**FILE** P. I. No. 0006814, Fayette County  
CSSTP-0006-00(814)  
Crosstown Drive at South Peachtree Parkway-  
Intersection Improvement

**SUBJECT** APPROVED PROJECT CONCEPT REPORT

**SUBJECT: PROJECT CONCEPT REPORT REVIEW**

PROJECT CONCEPT REPORT

**TYPICAL SECTIONS**

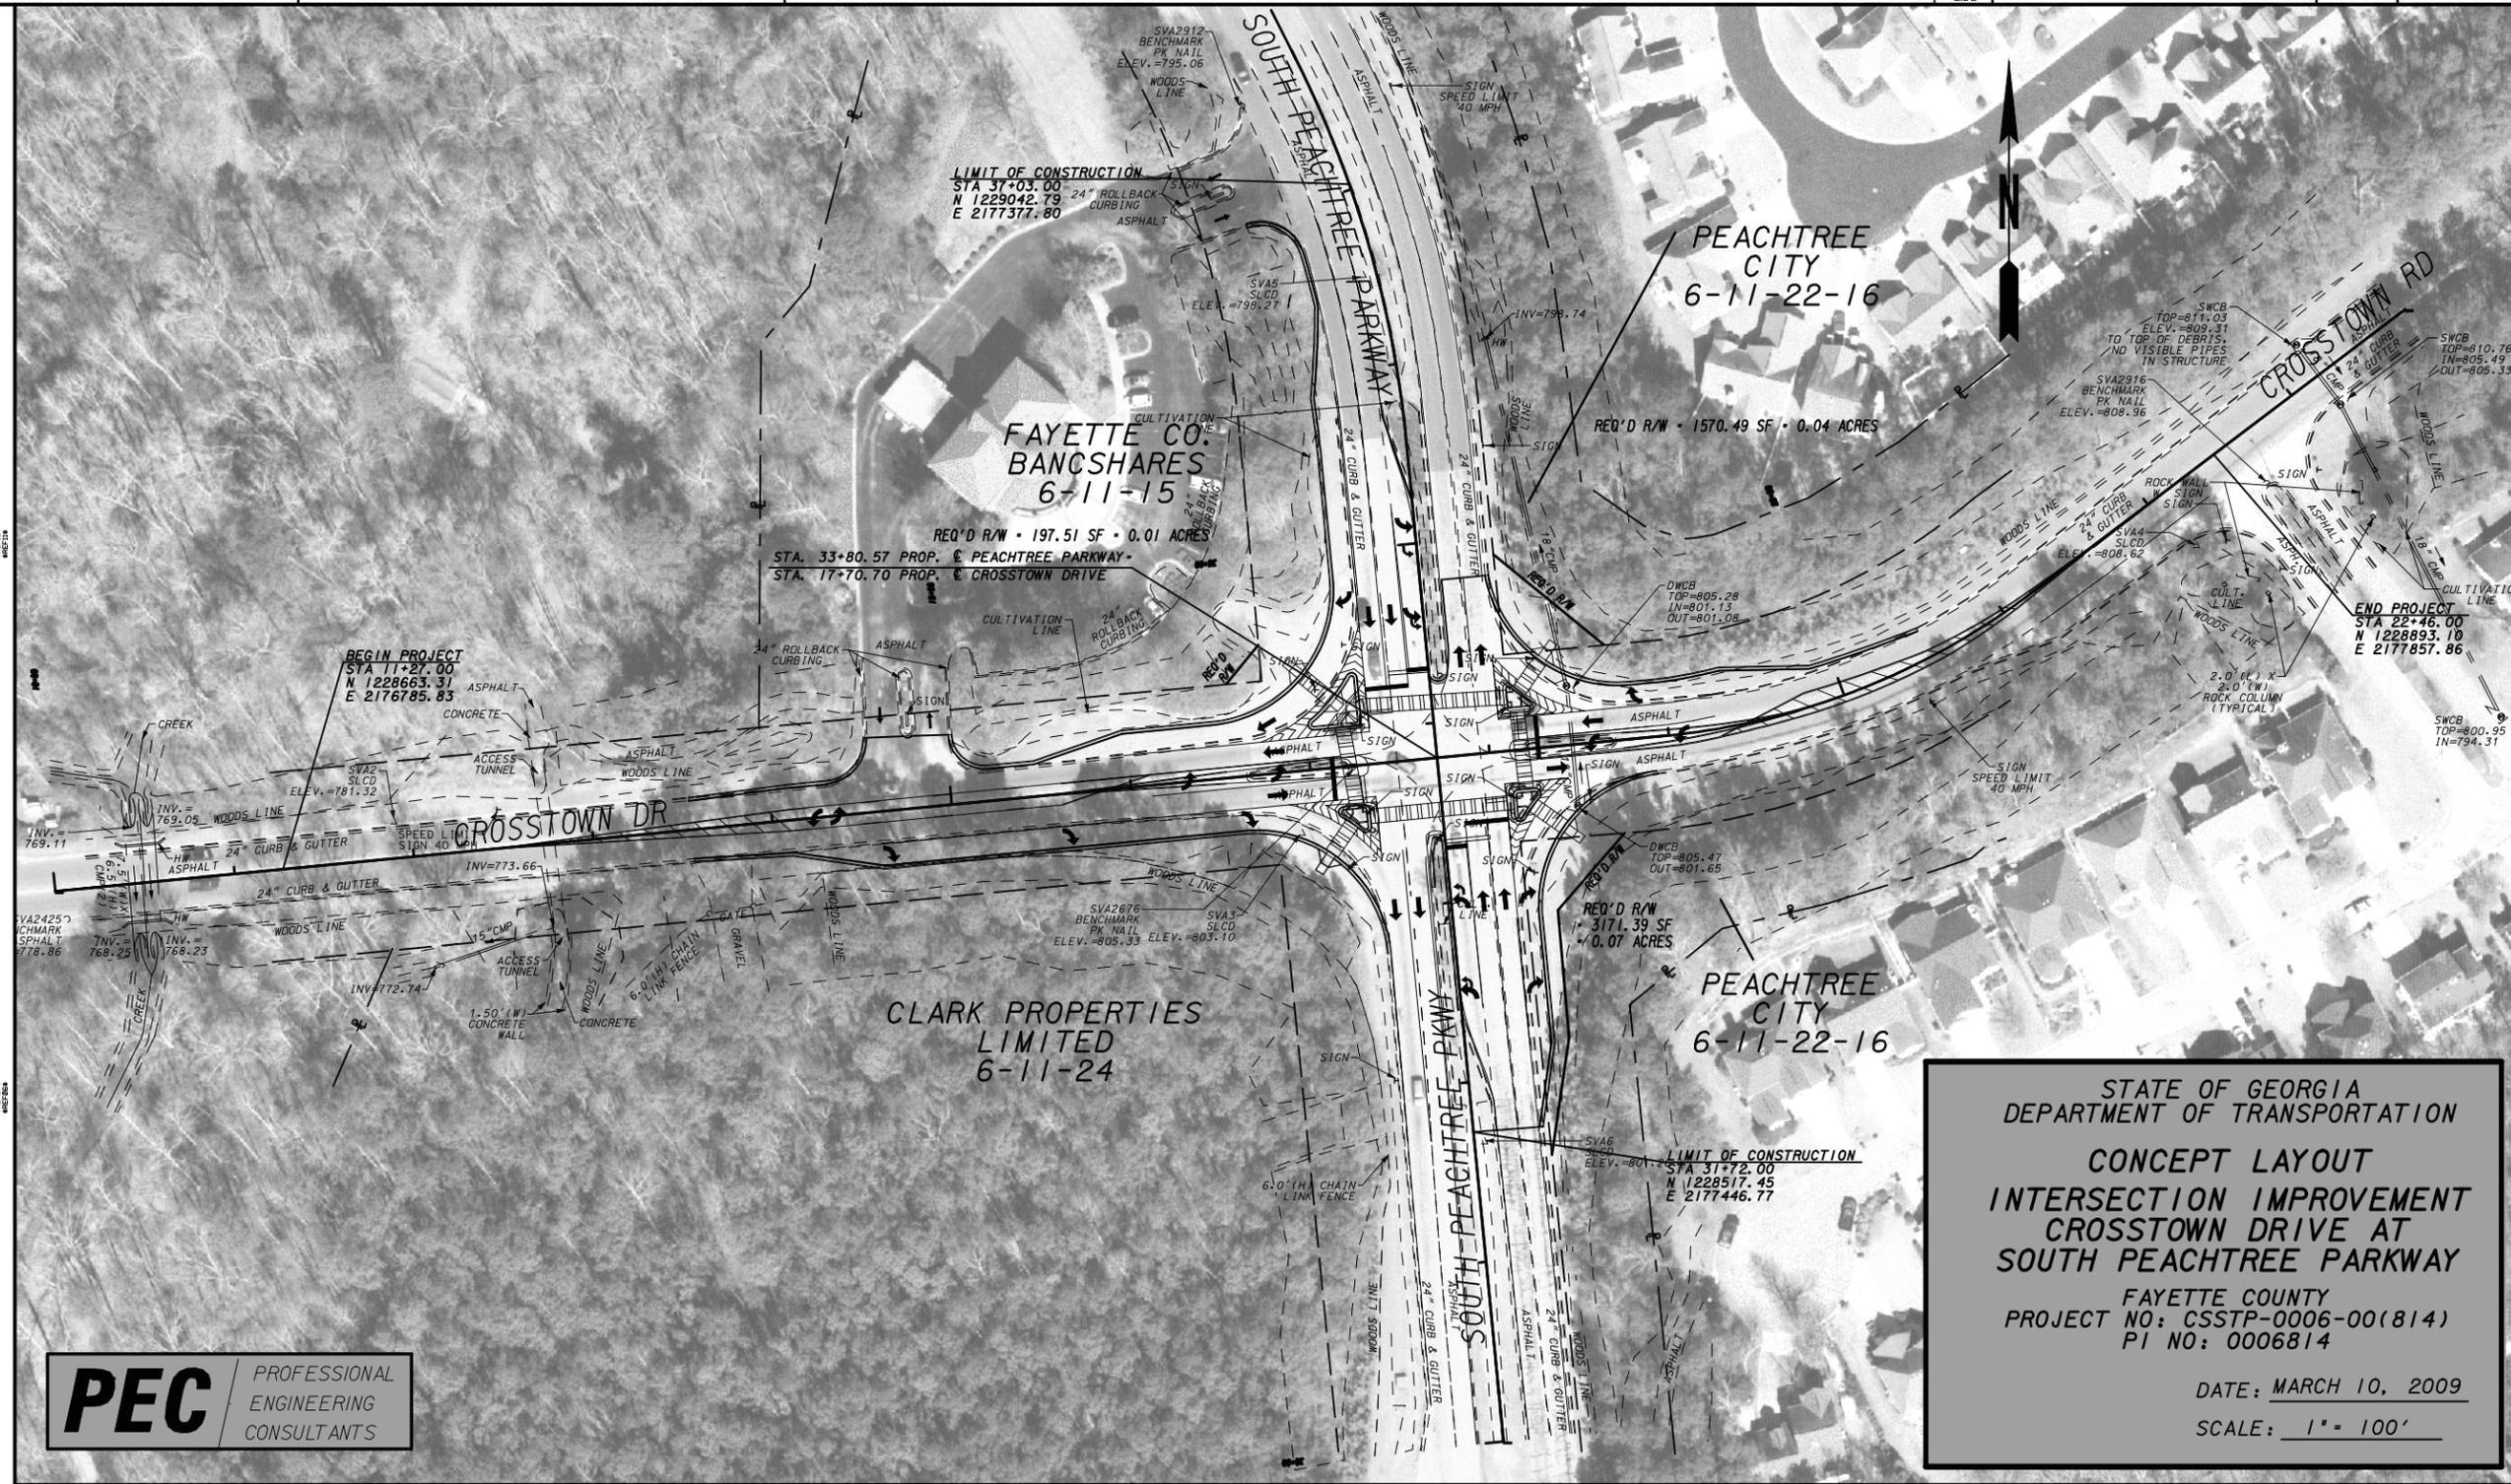
- Adjust cost estimate up per comments
  - Make sure the typical section is correct for this project. Section thickness appears too thick.
  - Fix typographical errors.
